# UNITED STATES PATENT AND TRADEMARK OFFICE

APPLICATION NO.	FILING DATE	FIRST NAMED INVENTOR	ATTORNEY DOCKET NO.	CONFIRMATION NO.
09/834,014	04/12/2001	Scott L. Jacobs	0262-005	5260

**Office Action Summary**

## DETAILED ACTION

FIG. 6

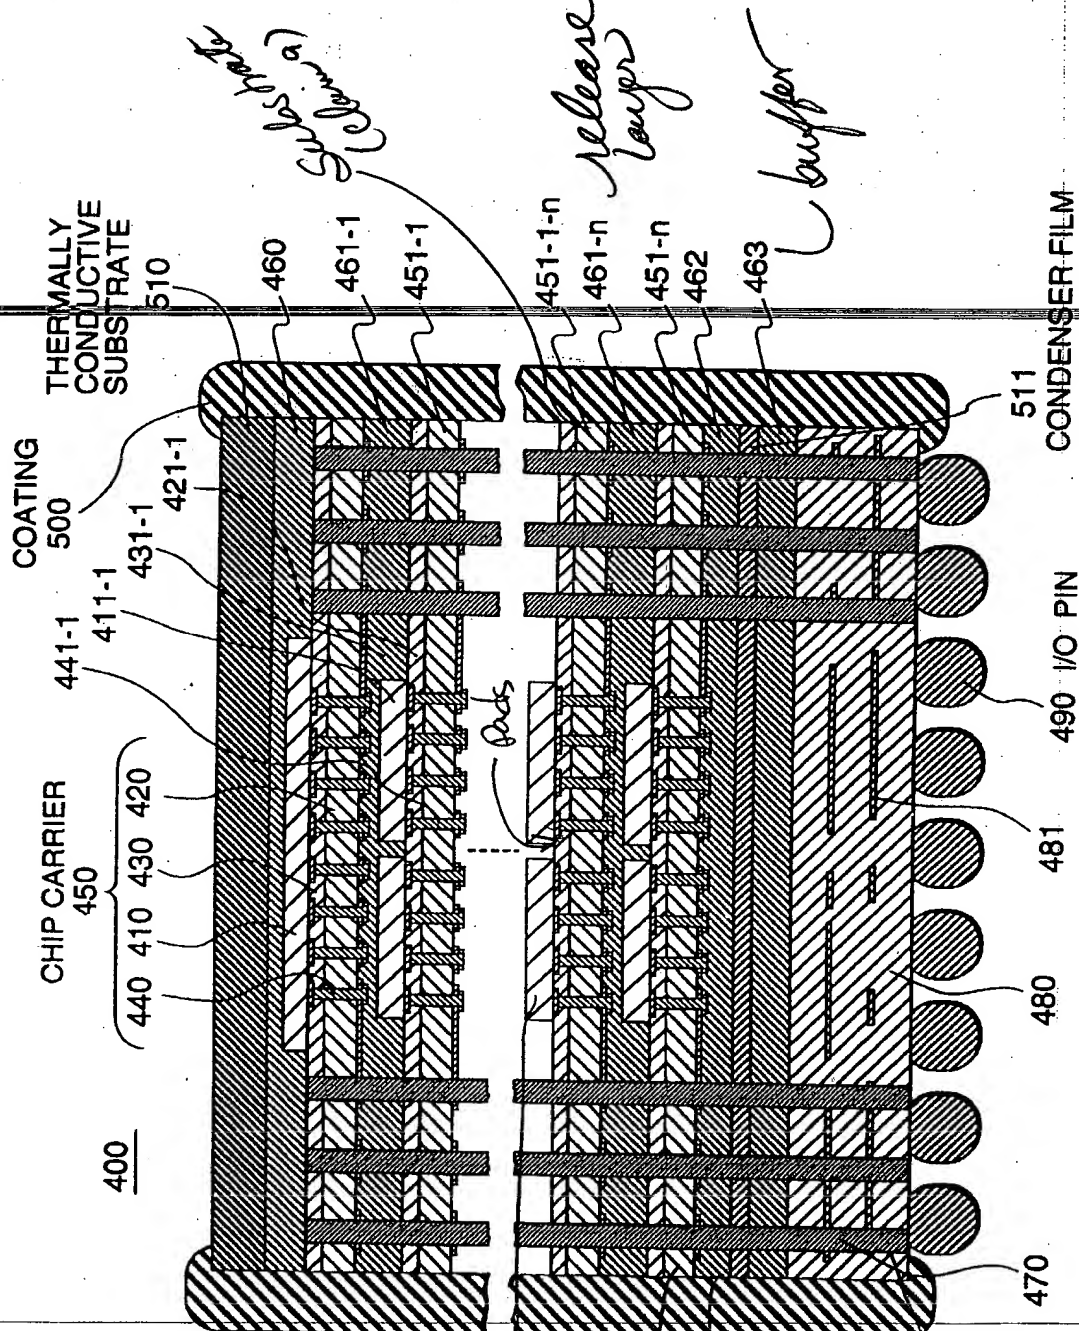
4. Regarding claim 1, Tokuda (e.g. attached fig. 6) shows a microelectronic package comprising:

- A first level substrate including a plurality of microelectronic devices 411 and a plurality of first level substrate input/output pads in a face thereof;
- A thin film decal 451 on the face of the first level substrate and having a first and second opposing faces;
- A second level substrate 480 including a plurality of second level substrate input/output pads on a face thereof;

- And a dielectric adhesive layer 462 adhesively bonded to the thin film decal and to the second substrate.

10. Regarding claim 9, Tokuda (e.g. attached fig. 6) shows a microelectronic package comprising:

- A substrate 451-1n;
- A release layer on the substrate 461-n;

- A thin film decal 451-n on the release layer, opposite the substrate, and having a first and second opposing faces;
- And a dielectric adhesive layer 462 adhesively bonded to the thin film decal.

21. Applicant's arguments filed on 04/04/2033 have been fully considered but they are not persuasive. Applicant argues that it is unclear which features of figure 6 of Tokuda the Examiner is seeking to map the terms of the claim. Nonetheless, Tokuda shows every limitation. As shown in the attachment and stated in the previous office action the first level substrate correspond to the elements 411 and not to the adhesive film 430, the input/output pads correspond to the pads 11 and not the top of the through hole connections 440, thin decal correspond to the substrate 451 and not the substrate 420 as suggested by Applicant. Moreover, Tokuda discloses that decal includes I/O pads in both sides. For example, Tokuda (e.g. fig. 3) I/O leads 150/151 connected to the decal I/O pads.
